KENDRA KAISER, PhD¹

Expert Witness Report

Hydrology Expert Report

Effect of Perpetua Resources' Water Right Applications on Surface Water Quantity and Groundwater Levels in the East Fork South Fork Salmon River Watershed

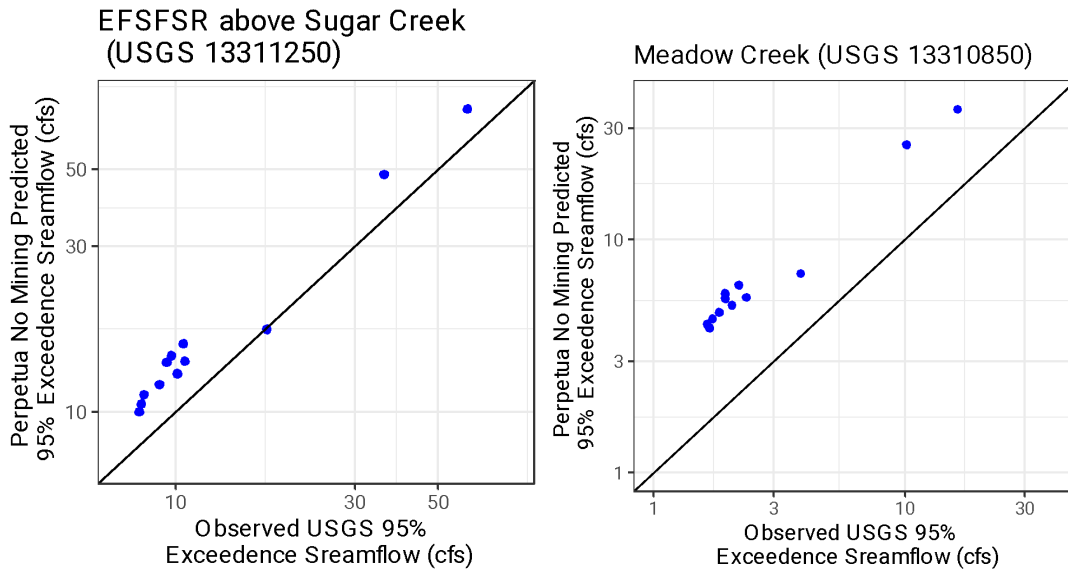
Perpetua’s SHSM predicts higher low flows than in the historical observational record (*See* Figure 3 below).

To quantify how well the SHSM performs at low flows, I calculated the monthly 95% exceedance flow using Perpetua’s simulated streamflow data under their “No Action” scenario (Table B-8: Meadow Creek 13310850 and B-11: EFSF above Sugar Creek 13311250, BC, 2021a) and compared it to the observed USGS record for those sites (*See* Figure 3 and Table 2 below). This comparison shows that Perpetua predicts low streamflows to be up to 305% higher than they actually are. This corresponds with Table 4-6 of the SHSM (Baseflow Calibration Statistics at the

USGS gages from November - February) where the Minimum Residual (difference between simulated and observed) for the EFSFSR above Sugar Creek can be up to -4.96 cfs in December, at which time the 95% exceedance at that site is 9.04 cfs. This means that Perpetua’s model could simulate the flow to be 13 cfs, or 133% of the actual flow. Although the calibration statistics Perpetua provided (RMSE) suggest that the model performs well, the magnitude of difference at low flows suggests otherwise. This, in conjunction with other results that are sufficiently vague (e.g., simulated basin yield does not capture the important seasonal variability in streamflows) prevent me from assessing actual effects on surface water and groundwater.
